GeoMat Testing Laboratories, Inc.

Project No. 16027-01

SUBJECT: Response to County of San Bernardino Geotechnical/Geological Report Review Sheet dated July 13, 2017, Proposed Islamic Community Center, Northwest Corner of Beaumont Avenue and Nevada Street, APN 0293-111-15-0000, Redlands, California

FIGURE 1

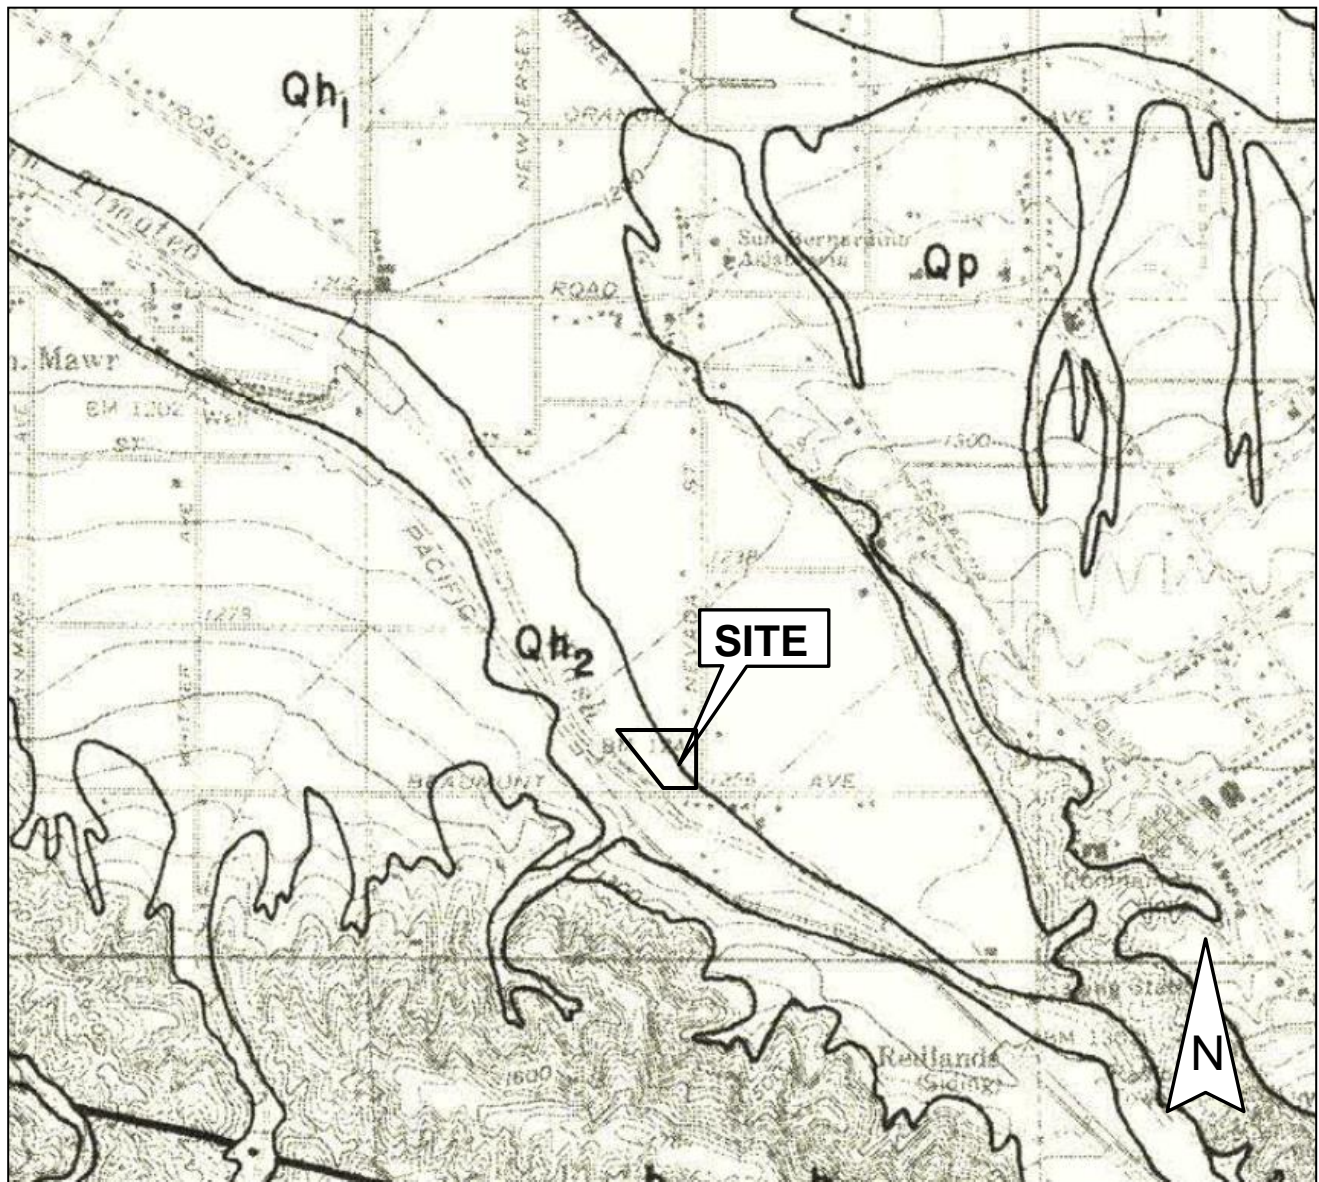
Comment 1) *The engineering geologist shall consider the following published geologic maps that covers the project site: CDMG SR 113 (Geologic hazards in southwestern San Bernardino County, California), USGS Open-File Report 2005-1278 (Hydrology, description of computer models, and evaluation of selected water-management alternatives in the San Bernardino Area, California), USGS Open-File Report 2003-0302 (Geologic map of the Redlands 7.5 minute Quadrangle, San Bernardino and Redlands Counties, California), USGS B 1898 (Liquefaction susceptibility in the San Bernardino Valley and vicinity, southern California – A regional evaluation), and USGS Water-Supply Paper 1419 (Geologic and hydrologic features of the San Bernardino Area, California). The latter of these maps indicate that the site is underlain by two geologic units, alluvium associated with recent sedimentation of San Timoteo Creek and younger alluvium associated with former channels of the creek, rather than the one unit displayed by Dibblee. The response report indicates that the closest active or potentially active fault is located approximately $\frac{3}{4}$ mile southwest of the site and identifies that fault as part of the San Jacinto Fault Zone. CDMG SR 113 identifies a west-northwest-striking fault about 3,000 feet southwest of the site as the Banning Fault. Open-File Report 2003-0302 shows this closest potentially-active fault to the site as the Live Oak Canyon fault zone. This west-northwest-striking fault zone may indeed be a branch of the San Jacinto Fault Zone, but should be also be referred to by the names used by the CGS and the USGS. The variations in the nomenclature suggest the complexity of faulting in this portion of the valley.*

According to USGS Bull 1898 (Figure 1), the site is underlain by Holocene-age alluvial deposits derived from sedimentation of San Timoteo Creek. The alluvium has been divided into Younger Holocene (Qh2) and Older Holocene deposits (Qh1) based on pedogenic soil development. The northeastern portion of the site is mapped as Older Holocene Alluvium (age ranging from 500 to 10,000 years, and possibly as old as 15,000 years). The southwestern portion of the site is mapped as Younger Holocene Alluvium (age ranging from approximately 500 to 1,000 years), closer to the San Timoteo Wash. The subject site in relation to the younger and older alluvial units is indicated on Figure 1.

Review of the above aerial photographs reveal that the subject lot was occupied by an orchard from 1938 through 1969. Curvilinear tonal variations across the ground surface appear to represent meanders associated with fluvial sediment deposition, and are consistent with the contact between younger and older Holocene alluvial units transecting the site from northwest to southeast as shown on Figure 1 (from USGS BULL 1898) and Figure 3 (from OFR 2003-0302).

FIGURE 2

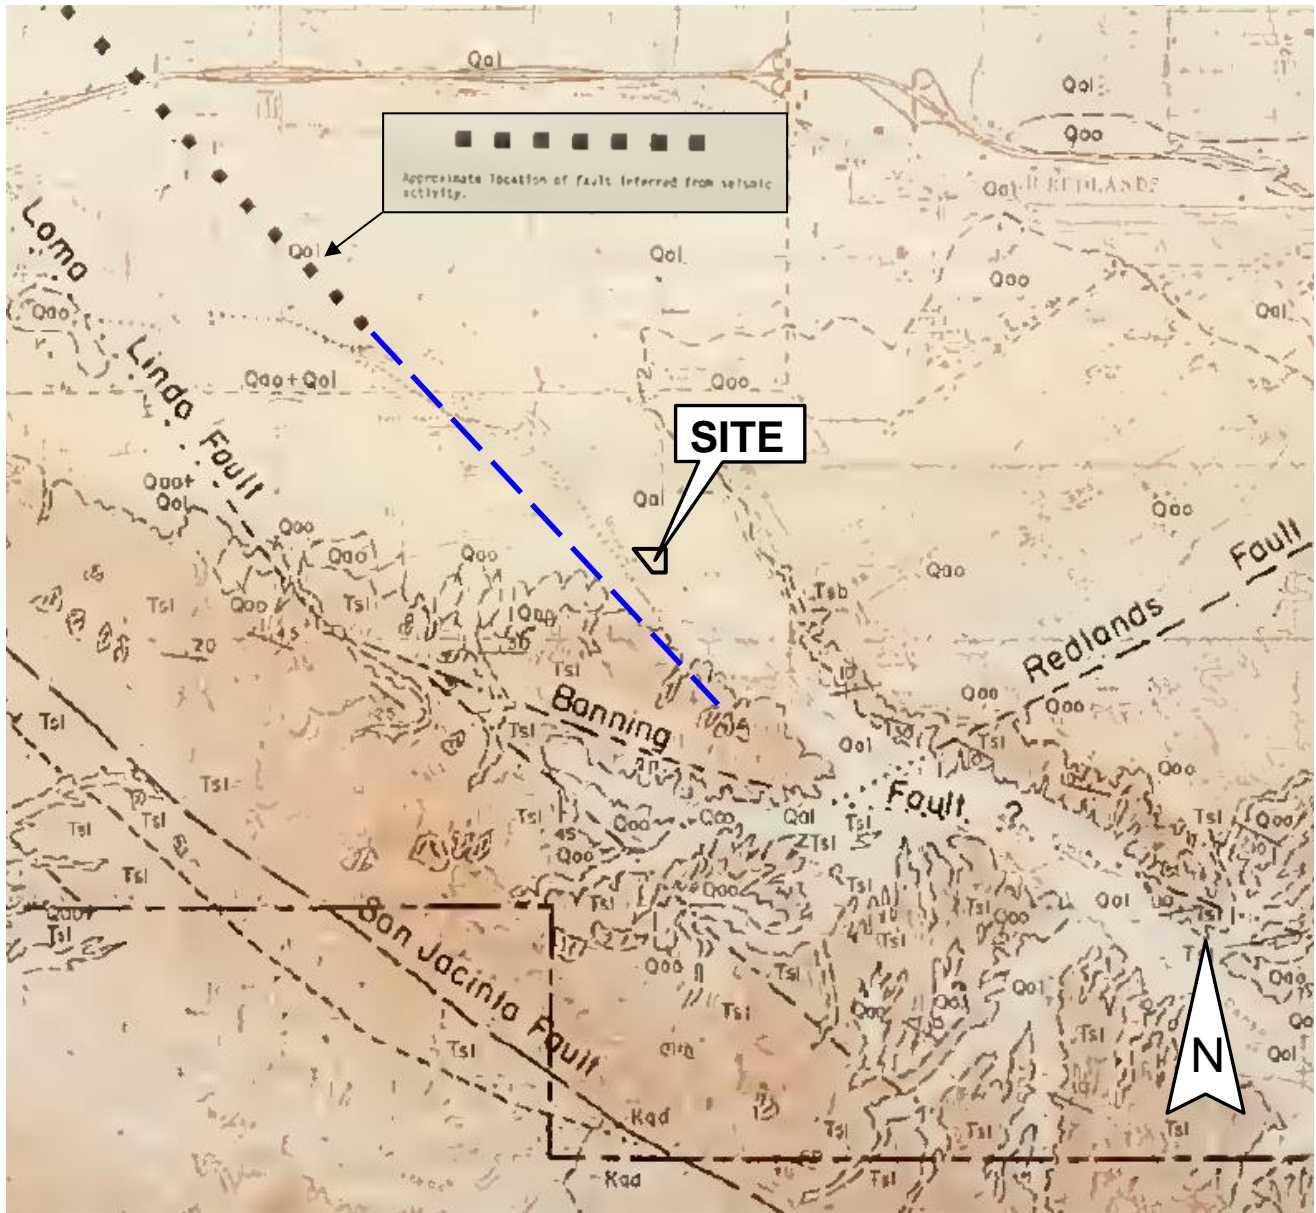
Comment 4) *CDMG SR 113 includes evidence for an inferred, northwest-trending fault that projects southeastward towards the vicinity of the site, based on seismic activity. USGS OFR 2005-1278 identifies this fault as the Banning Fault. The alluvial thickness (isopach) map presented as part of CDMG SR 113 includes evidence for a buried, northwest-striking escarpment southeast of the site, generally on trend with this inferred fault. CDMG SR 113 shows an unnamed northeast-trending groundwater barrier in the immediate vicinity of the northern portion of the site. USGS OFR 2005-1278 identifies this feature as the Bryn Mawr Barrier. The section of the response report that addresses faulting does not include an aerial photograph review for surficial evidence of active faulting, nor are any aerial photographs cited in the reference section of the report. Considerable evidence exists for the presence of as yet unmapped, high angle strike-slip and/or oblique-slip faults rupturing older alluvial materials within San Timoteo Canyon, southeast of the site. The project engineering geologist shall include a review of available aerial photographs covering the site and vicinity to address the potential for active faulting, including faulting depicted by CDMG SR 113 and USGS OFR 2005-1278. Resources are available locally at the San Bernardino County Flood Control District, the Water Resources Institute at California State University at San Bernardino, as well as from the US Department of Agriculture and US Geological Survey. Virtual three dimensional aerial photographic imagery is also available on-line from Google Earth Pro and NASA World Wind. Aerial photographic imagery utilized for the aerial photograph review shall be cited in the references section of the report.*

According to SR 113 (Morton, 1974) a northwest-trending fault is located approximately 3,600 feet southwest of the site; this fault is labeled “Banning Fault” according to this reference. The active San Jacinto fault is mapped approximately 1.8 miles southwest of the site according to this reference. The subject site in relation to faulting presented in SR 113 is indicated on Figure 2.

According to CDMG SR 113 (Morton, 1974) an "inferred northwest-trending fault that projects southeastward toward the site based on seismic activity" is located approximately 1 ½ miles northwest of the site (see Figure 2). Extrapolation of this fault toward the subject site shows that it passes southwest of the site, across the San Timoteo Creek channel, along the base of the southwesterly-ascending hills. CDMG SR 113 also contains an alluvial isopach map (see Figure 7) showing contours of alluvial thickness. The contours appear concentrated at a location south-southeast of the site, which may be evidence for a deeply buried escarpment feature along the base of the ascending hills southwest of the San Timoteo Creek channel, approximately ¼- to ½-mile from the subject site, which also roughly aligns with the inferred fault projection discussed above and highlighted on Figure 2.

1945 GW CONTOURS – OFR 2005-1278

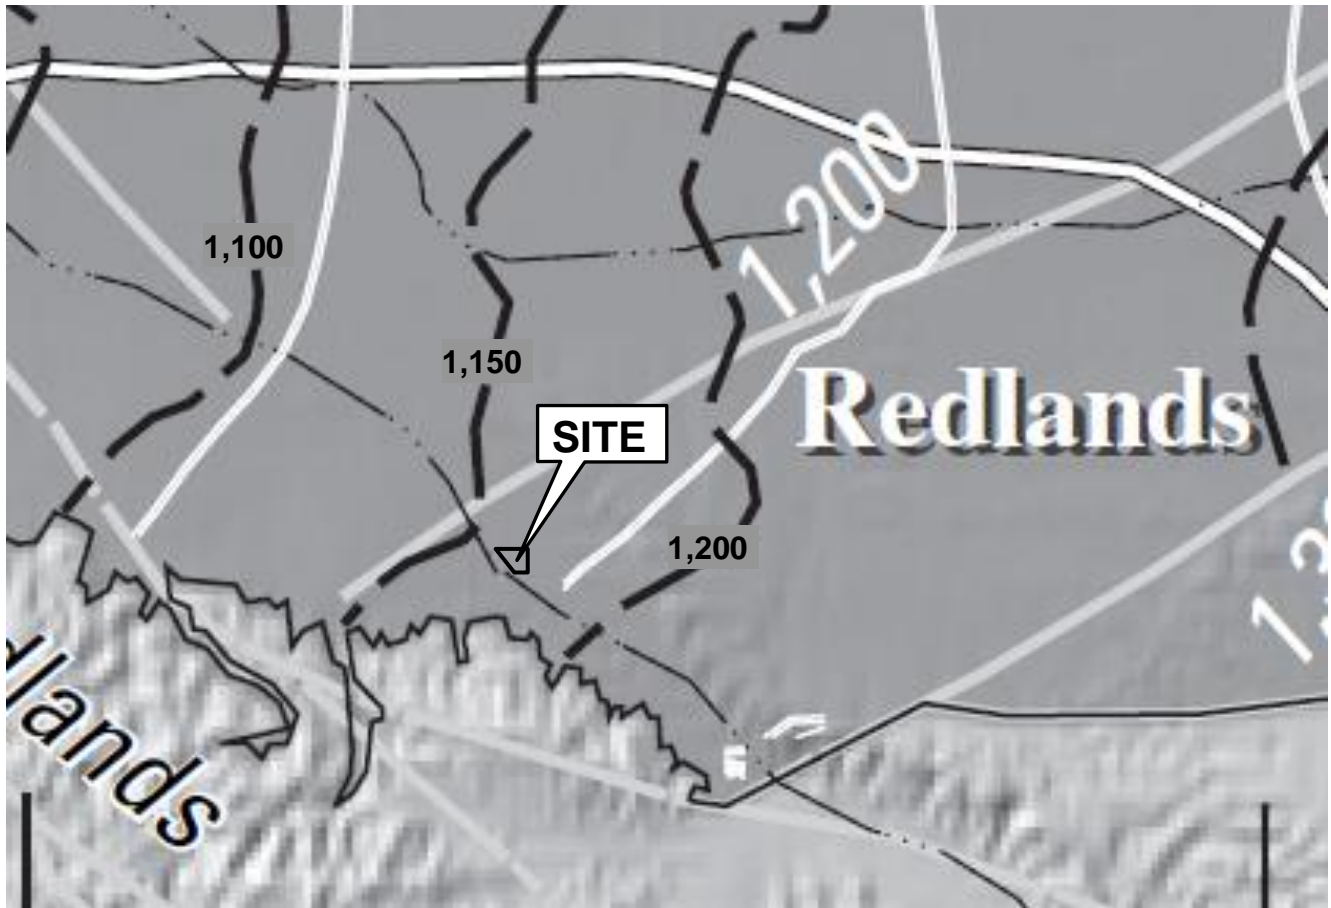
Comment 2) *The site is located immediately northeast of channelized San Timoteo Creek. Water-Supply Paper 1419 includes phreatic groundwater elevations for the periods 1936, 1945, and 1951. USGS OFR 2005-1278 also shows groundwater elevations in the vicinity of the site from 1945 that suggest a depth to groundwater of approximately 50 feet at the site. CDMG SR 113 presents depth to groundwater in the vicinity of the site from the 1960's. USGS B 1898 provides minimum depth to groundwater data for the site and vicinity during the period 1973 to 1983. The project geologist shall reference the groundwater data presented by these publications in the report. The use of groundwater data from individual wells located away from the site can be used to supplement these historic compilations, but should include an estimated depth to groundwater at the site based on extrapolation of groundwater gradients in the area at the time of the measurements.*

According to USGS Open File Report 2005-1278, the 1945 ground water elevation contour beneath the subject site was 1160', corresponding to a depth of approximately 90' below the current surface grade (see Figure 4). According to this reference, the 1945 ground water elevation contour gradient is approximately 57' per mile along San Timoteo Wash, in an area bracketing the subject site. Extrapolation of the Spring 2017 ground water elevation of 1050.6' (136' depth) from a well approximately 1 mile northwest of the site (Bryn Mawr #4, State Well #01S03W31B001S, El. 1186.6'), located along the alignment of the San Timoteo Wash, would yield a ground water elevation of approximately 1108' (or 142' depth) at the subject site.
